Groundwater Application Review Summary Form

Application # G- 18605

To: Kristopher Byrd, Well Construction and Compliance Section Manager
From: Joel Jeffery, Well Construction Program Coordinator
Subject: Review of Water Right Application G-18605
Date: September 25, 2018

PUBLIC INTEREST REVIEW FOR GROUNDWATER APPLICATIONS

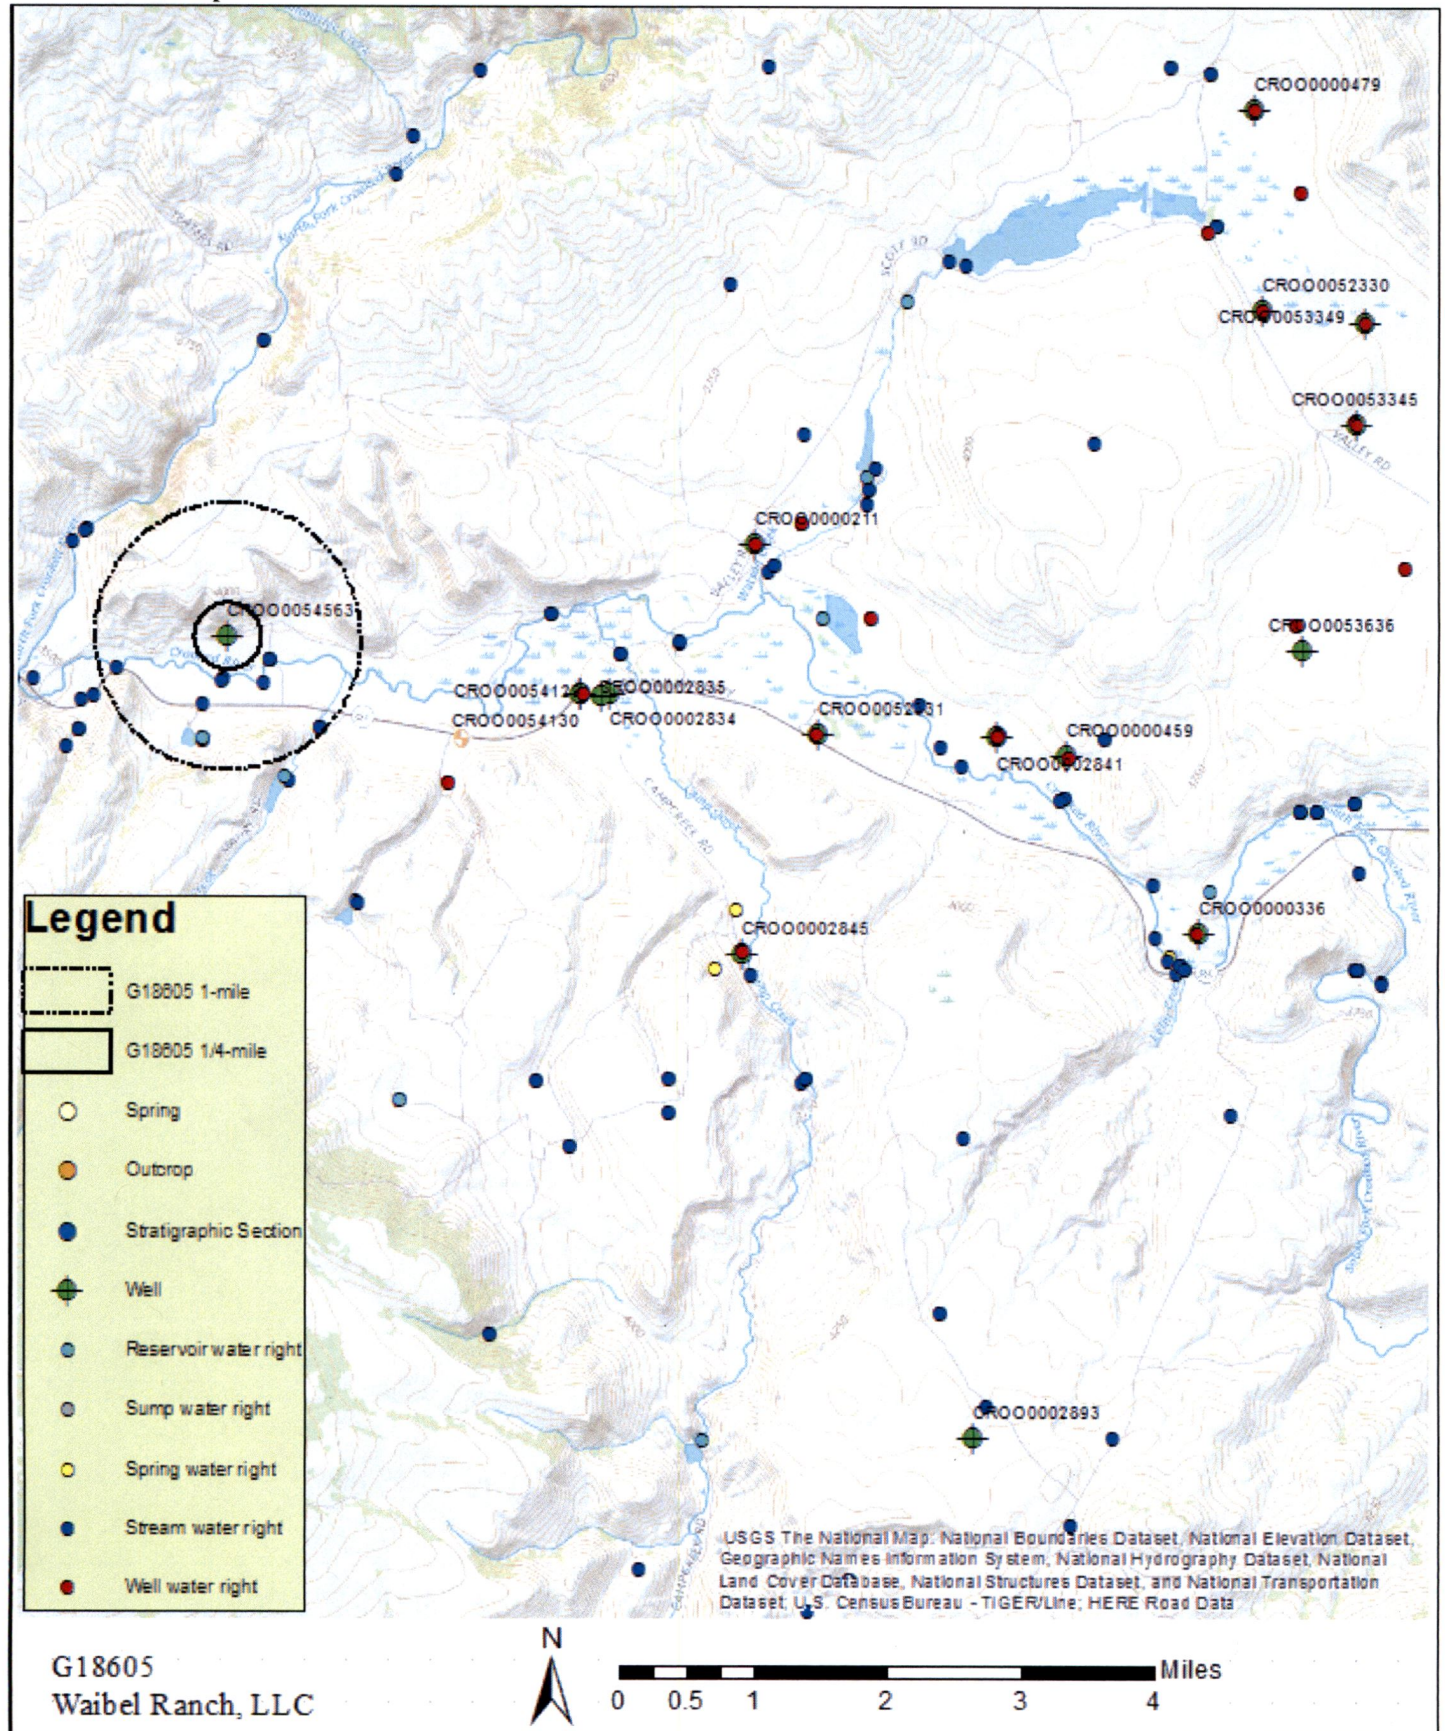
D2. **THE WELL does not appear to meet current well construction standards based upon:**

D3. **THE WELL construction deficiency or other comment is described as follows:** _____

D4. **Route to the Well Construction and Compliance Section for a review of existing well construction.**
